**Re: Jackson Hydroelectric Project, FERC Project No. P-2157
Marsh Creek Slide Plan**

Marsh Creek Slide Monitoring and Modification Plan

Henry M. Jackson
Hydroelectric Project
(FERC No. 2157)

Consultation on Draft MCS Plan

Figure 1: MCS Modification Flow Chart

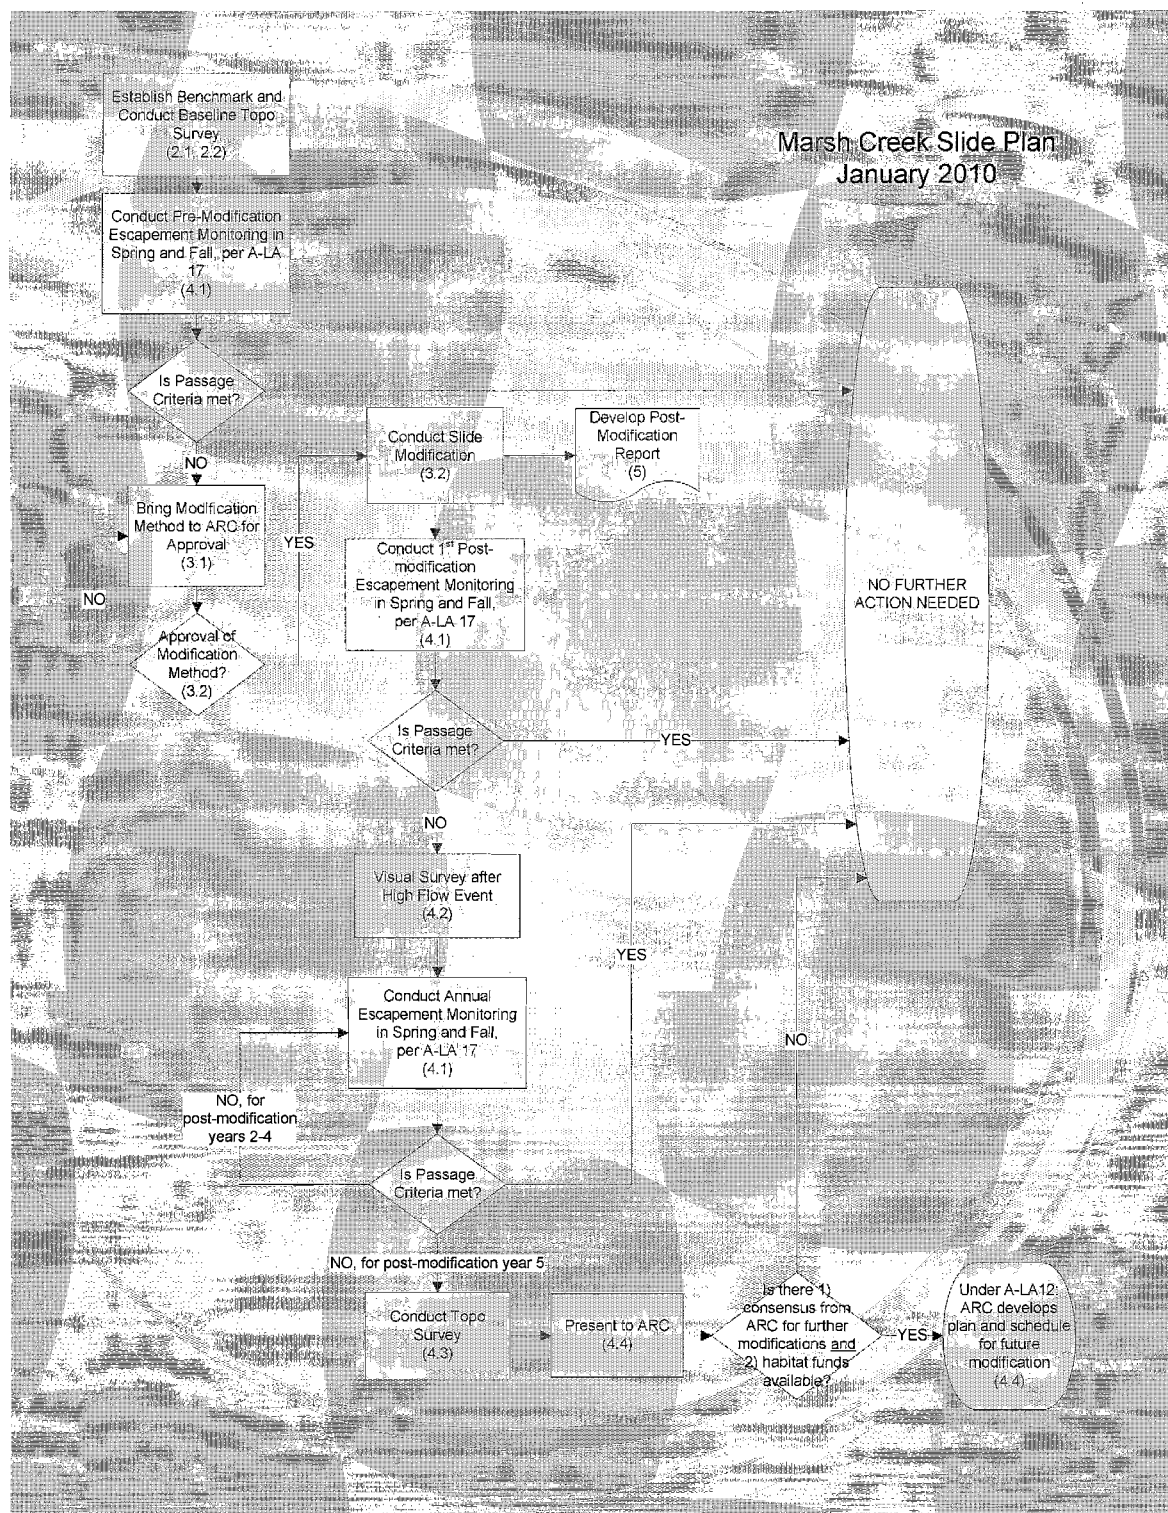
It looks like the decision criteria is in the flowchart, but not the narrative. Here is the recommended language to add to the narrative to establish a criteria for proceeding with the project.

- NMFS and USFWS suggested removing ESA consultation from the permitting requirements as the license would already cover ESA consultation for this license article.
- USFWS suggested the District add a step in the Figure for ARC review and approval of the exact modification methods.
- Under Section 2.1, page 4, WDFW suggested remove reference to flashiness of the river as it provides no substance to the plan and no definition for flashiness. WDFW stated that parts of the river below hydroproject should have less “flashy” flows because of our ability to control the flow to some degree.
- WDFW suggested referencing the fish passage criteria in the modification section.
- Ecology suggested that the District also conduct a snorkel survey/count fish below the MCS as this may also indicate if fish are passing the MCS.

Please add to beginning of section 3.2 on p. 5 :

“Slide modification decision point, (i.e., determine if slide modification is necessary as discussed in settlement agreement A-LA 2, paragraph 3, bullet (6)).

If the prior annual escapement of chinook and steelhead trout in the spawning index area (RM 9.2 – 9.7) exceeds 10% of the total annual escapement of chinook and steelhead in the entire river downstream of the diversion dam, passage modification plans will be put on hold. If the diversion dam index area exceeds 10% of the total annual escapement of chinook and steelhead for three consecutive years, the fish passage modification plan will be suspended indefinitely. On the other hand, if the Diversion Dam Index Area Annual Escapement falls below 10% for three consecutive years, the slide modification plan will be implemented. “

The District agreed to the above modifications to the draft plan. Any additional comments are due by January 20. Those present stated that if no additional comments come in by January 20, they are in agreement that the plan is good for filing with FERC. See handout for updated draft MCS Plan.
